## **BID ADDENDUM NO. 3**

### **Johnson Student Center**

### **Building Demolition, Increment 1 (Demolition) and Increment 2**

RANCHO SANTIAGO COMMUNITY COLLEGE DISTRICT  
SANTA ANA, CA

DRAWING NAME: K:\2018\152032\_Santa Ana College\_Johnson Center\3\SKC-3.01 - W Plaza Sewer.dwg  
 PLOT DATE: 09-18-18  
 PLOTTED BY: szac

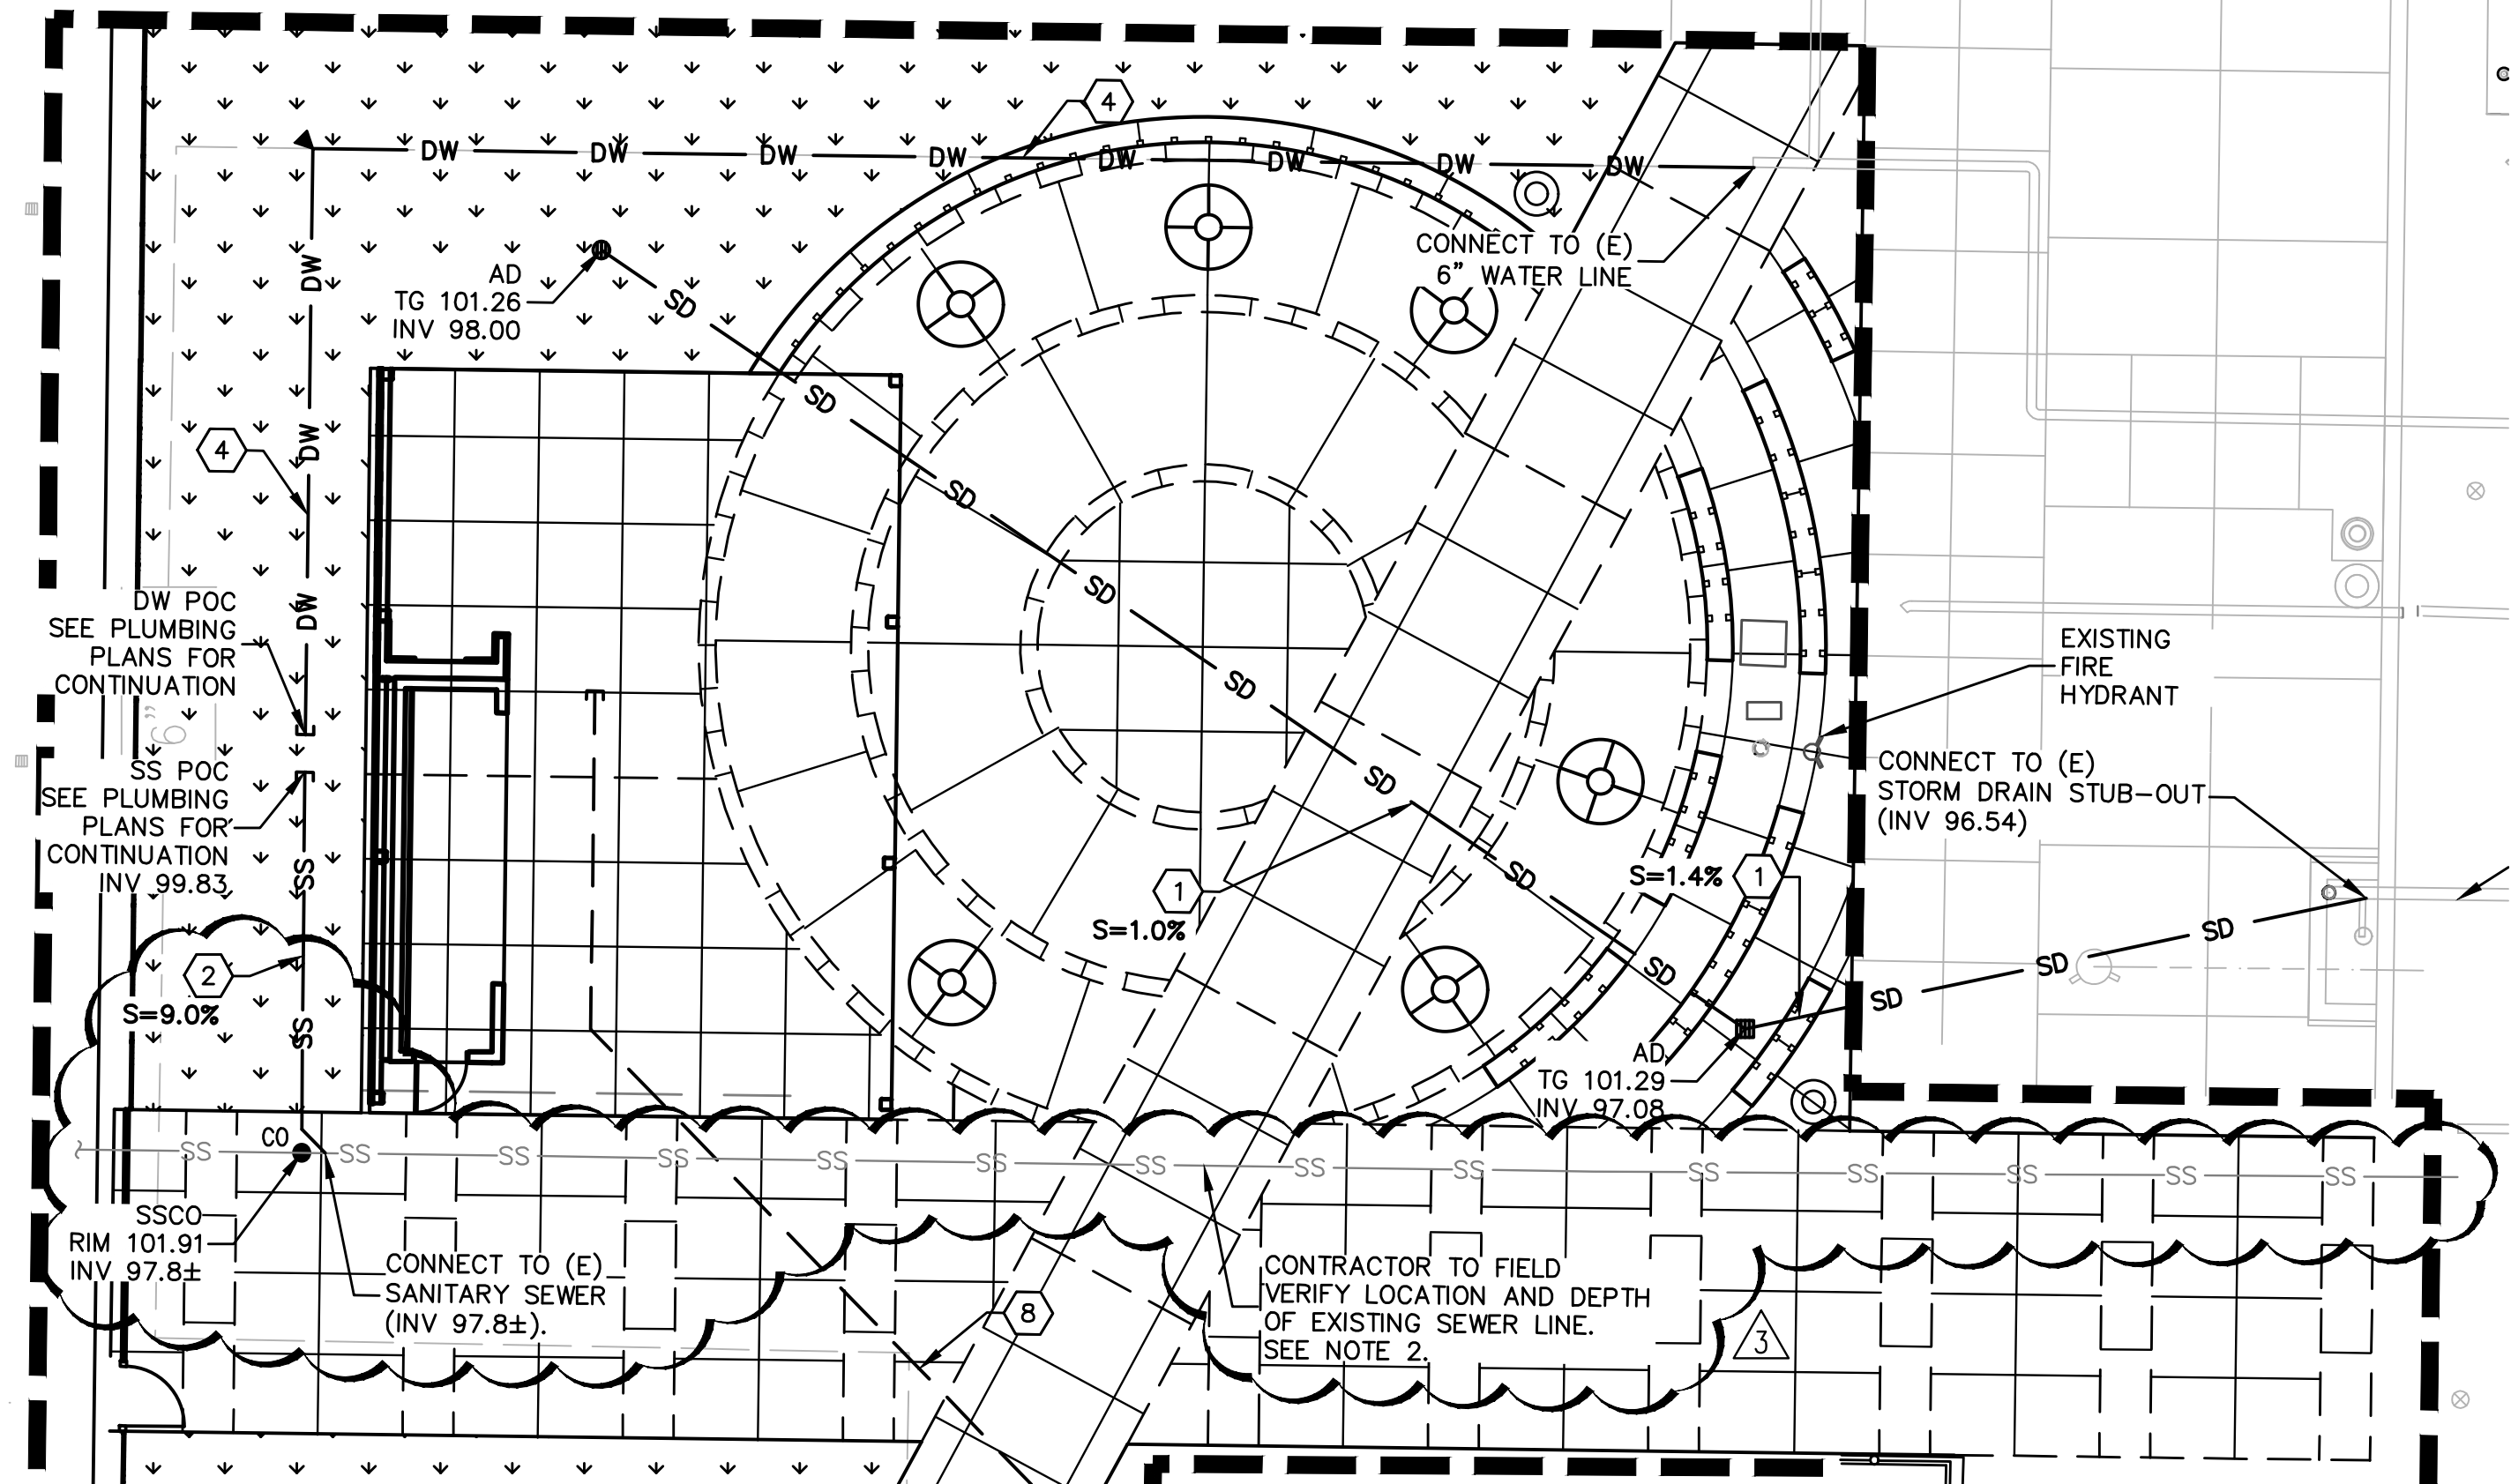
- Building Demolition
  - i. Revised sheet C1.00, refer to clouds and delta 3
    - 1. Refer to landscape, hardscape, underground wet/dry utilities being removed/demoed in their entirety in lieu of being protected.
    - 2. Revised/removed notes as needed for phasing of work with increment 1 and 2.
  - ii. Remove sheet C2.00 in its entirety and refer to Increment 1 and 2 erosion control and grading plans.
- Increment 2
  - i. Modifications to the West Plaza: The proposed sewer lateral, serving the West Plaza kiosk, connected to the existing 12" sewer line east of the plaza. Due to conflicts with the kiosk footing and the layout of the proposed sewer later, the lateral point of connection was revised and is now proposed to connect to the existing sewer line, running east/west through the West Plaza site. Refer to SKC-3.01

**SS1.02.1**

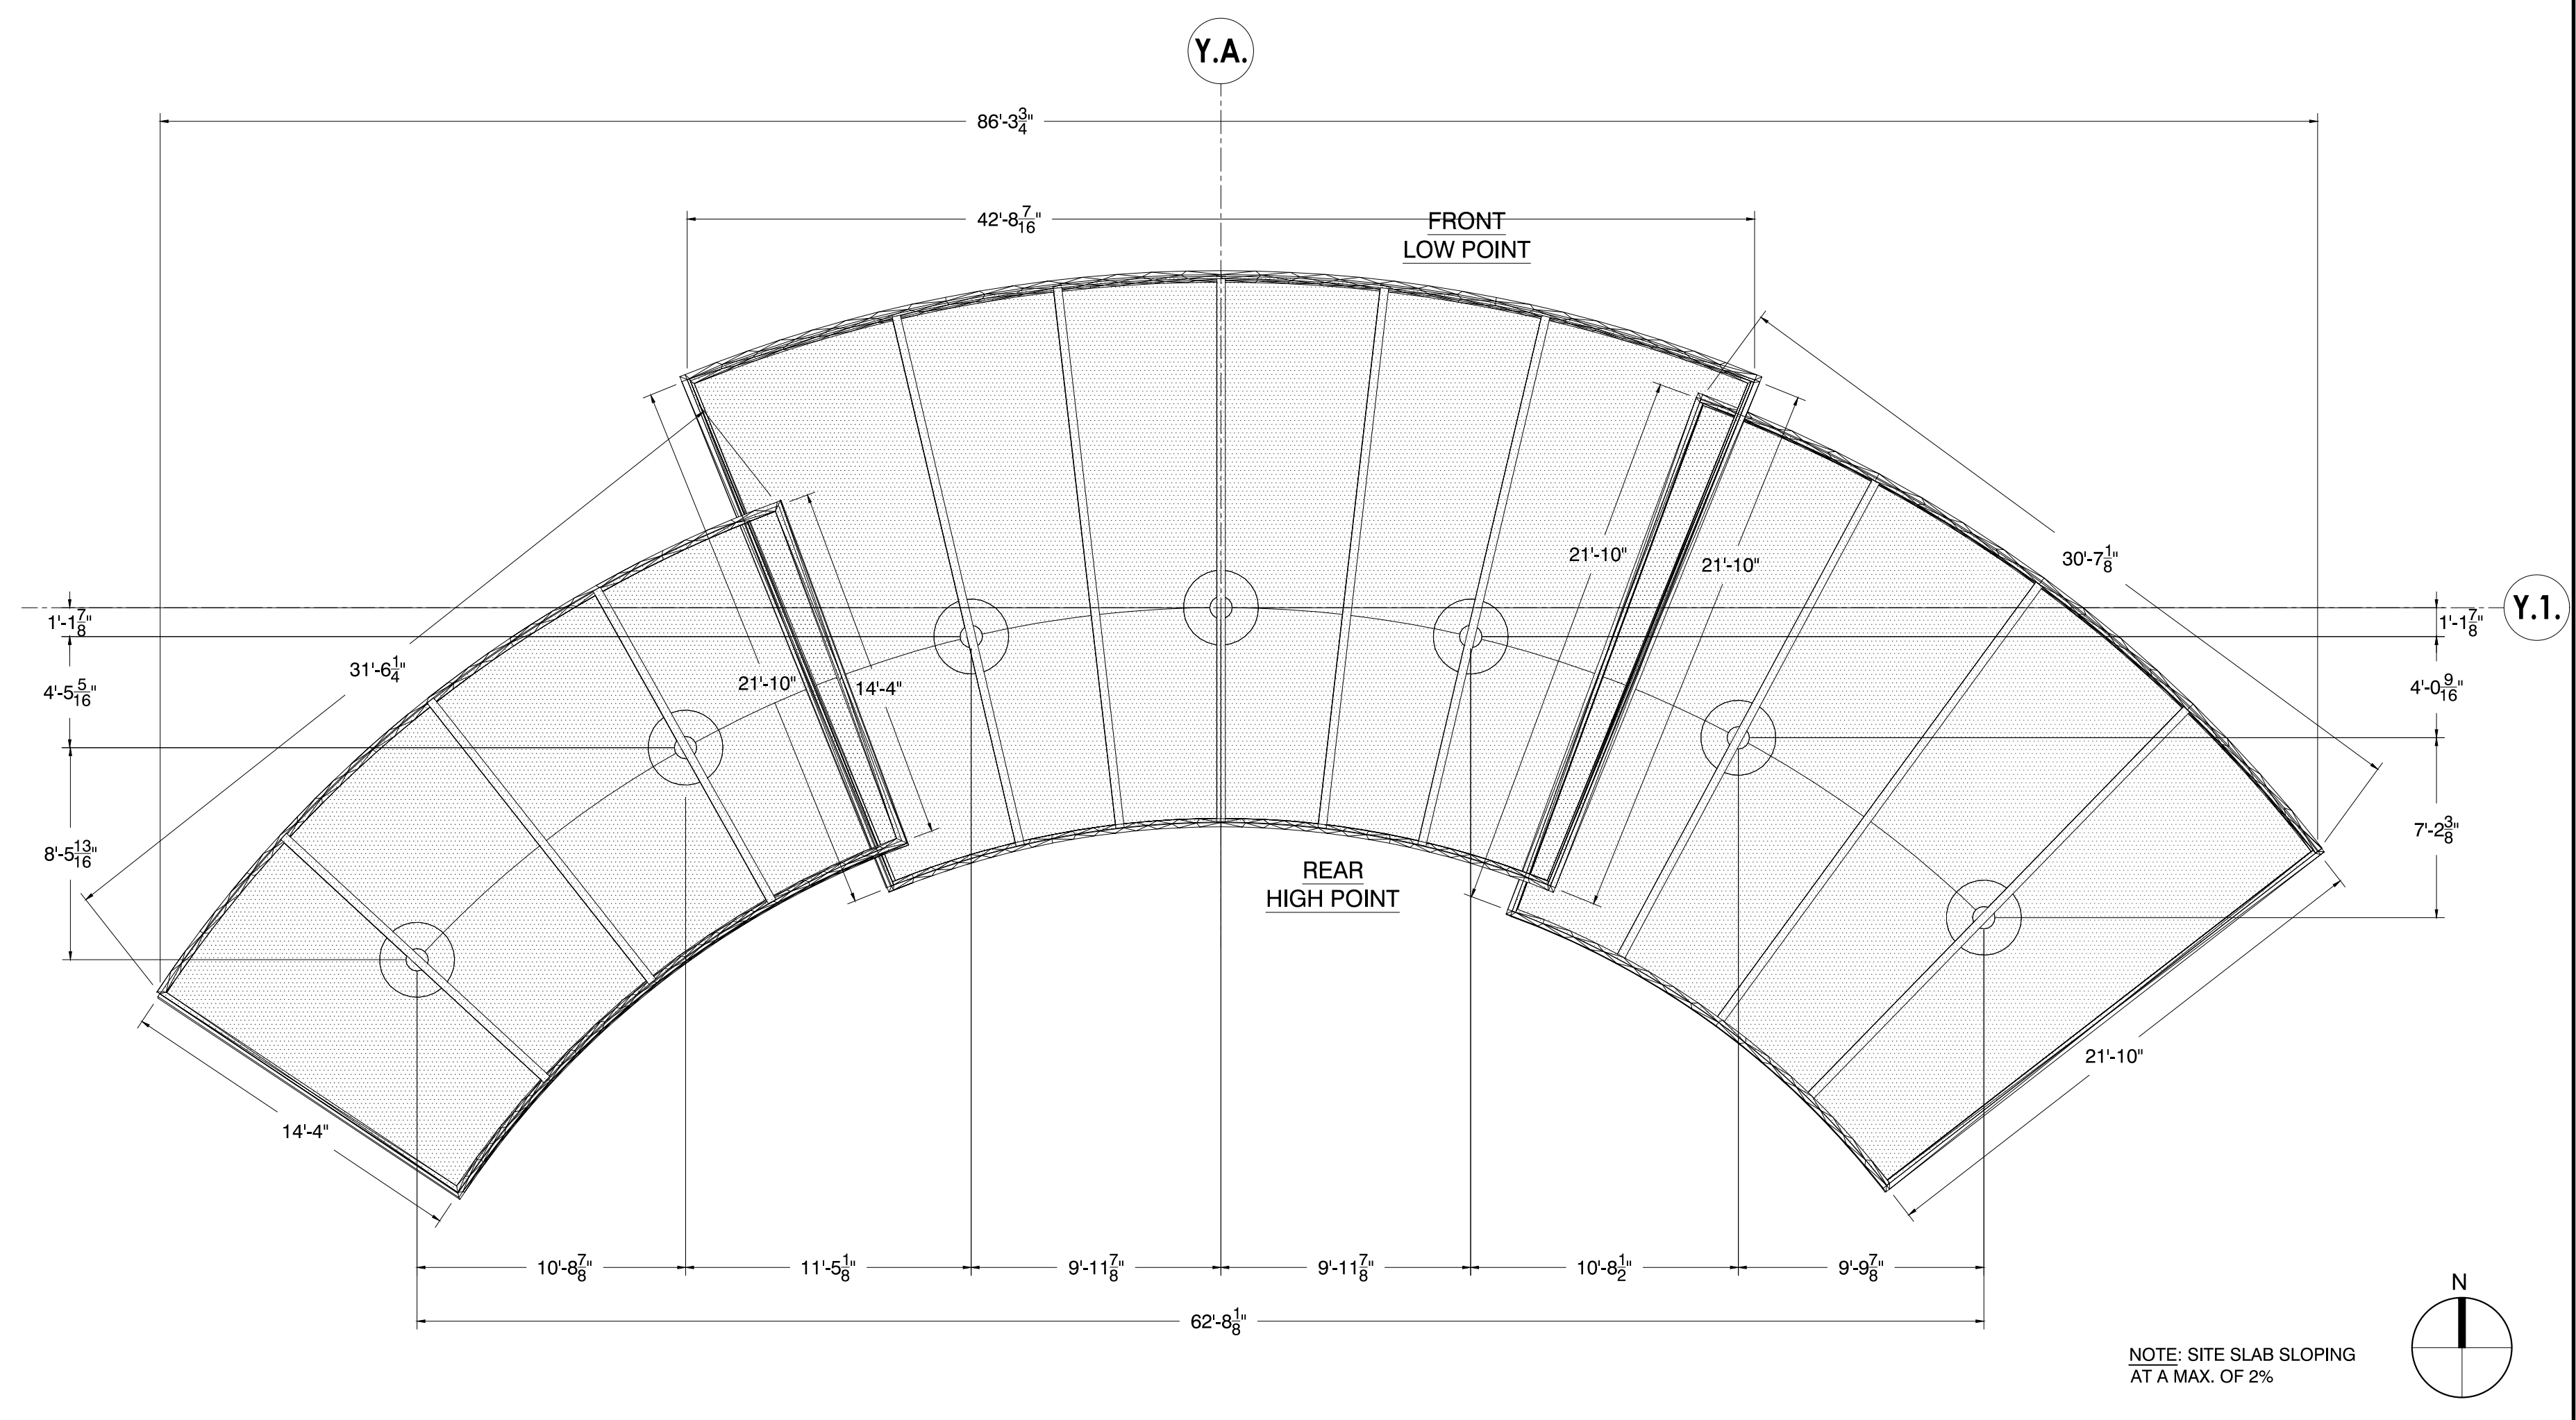
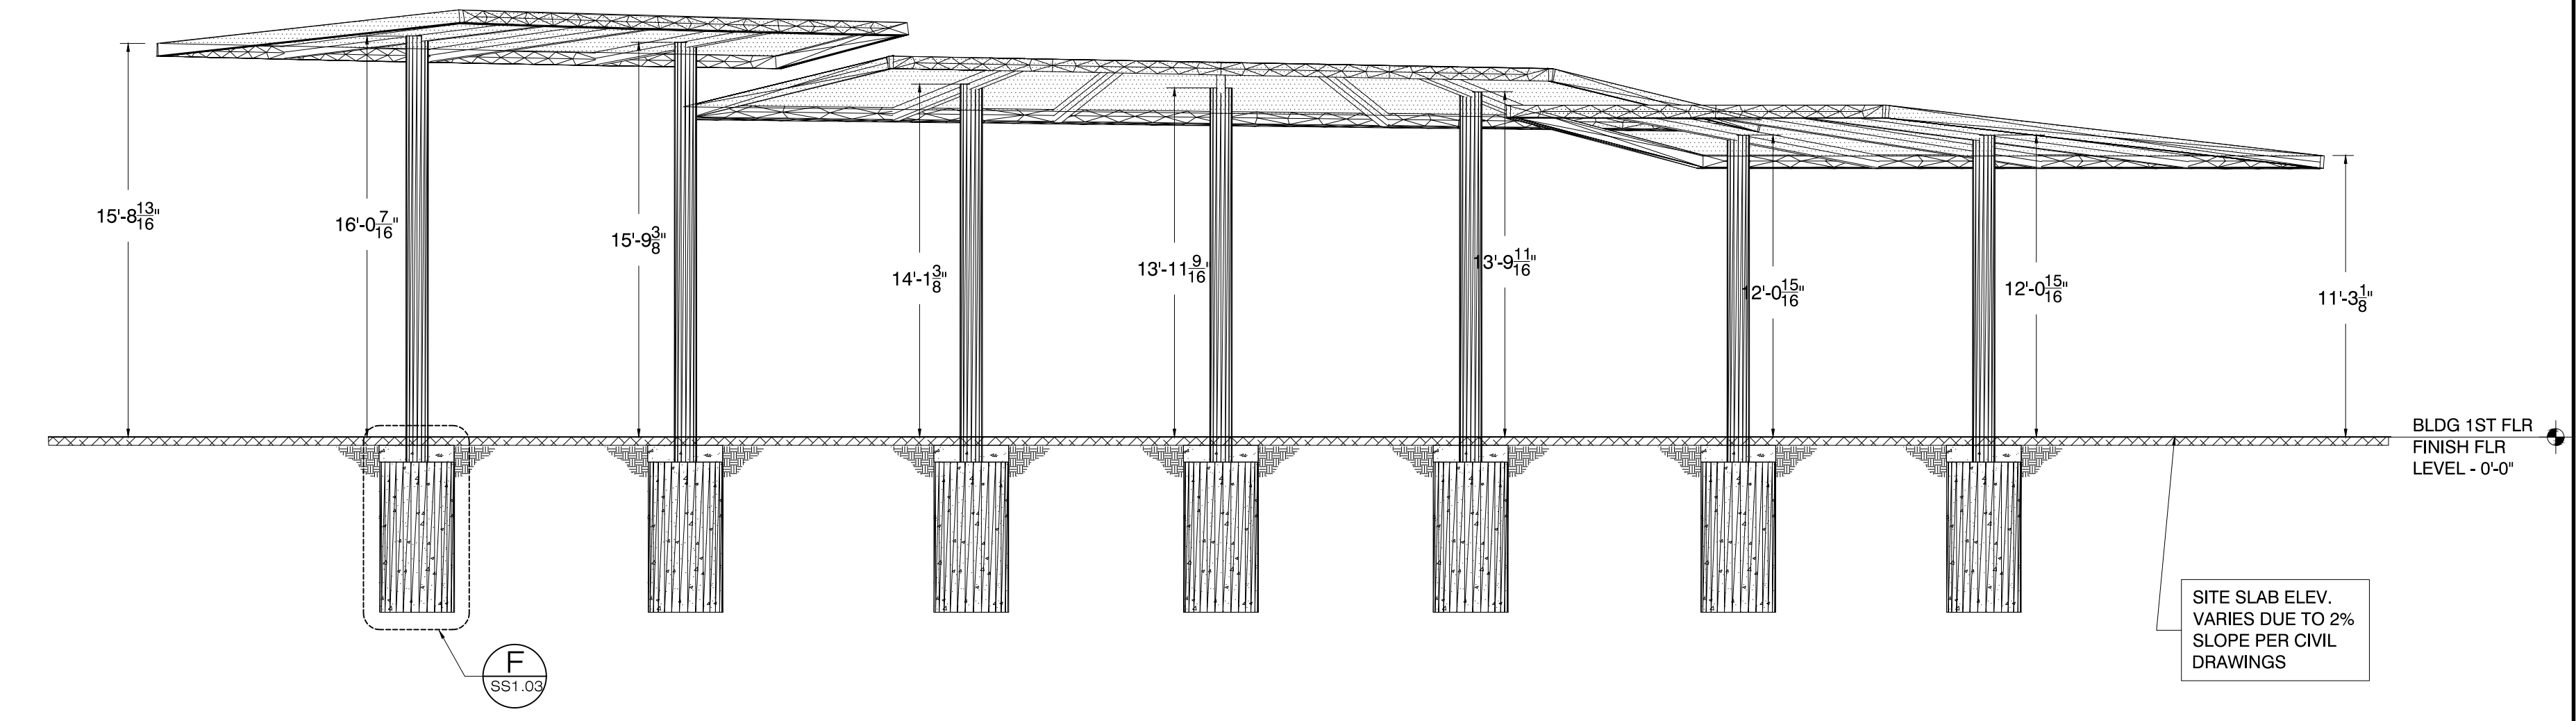
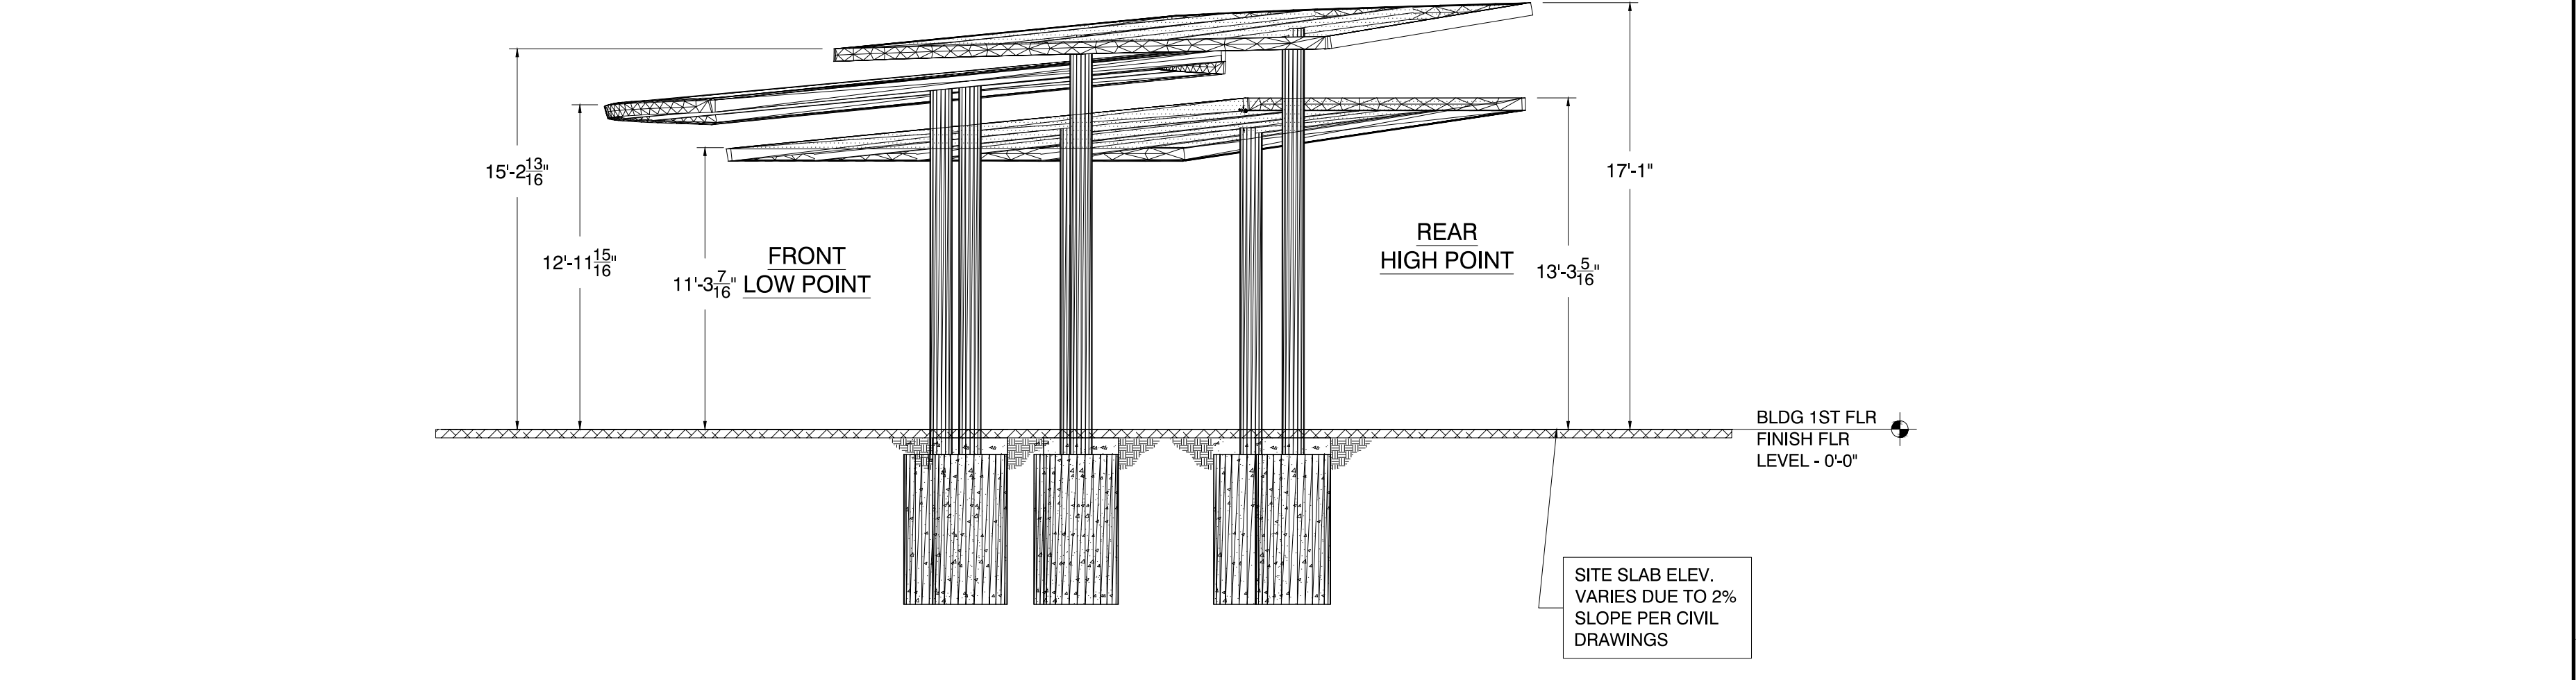
- Increment 2
  - Revised sheet SS1.02.1
    - Detail call out on SS1.02.1 Rear Elevation referenced F/A1.03 for the shade footing, this call out was revised to F/SS1.03.

DATE:	09/18/2018		
FROM:	S.Monsen - McCarthy	EMAIL:	SMonsen@McCarthy.com
SPECIFICATION NUMBER:		DRAWING NUMBER:	SS1.02.1
REQUESTED CLARIFICATION:			
Increment #2 - Sheet SS1.02.1 - Rear Elevation - The reference call out to Detail F/A1.03 for the Shade footing should be Detail A/SS1.03 instead.			
RESPONSE TO CLARIFICATION, <b>SUBMITTED AS PART OF AN ADDENDUM:</b>			
<b>MHP Response: 9/19/2018</b> <b>Sheet SS1.02.1 - Rear Elevation - The reference call out Detail F/A1.03 for the shade footing should be Detail F/SS1.03</b> <b>-AE</b>			
RESPONSE PROVIDED BY:	<b>Adam Egan / MHP</b>	DATE:	<b>09/24/18</b>
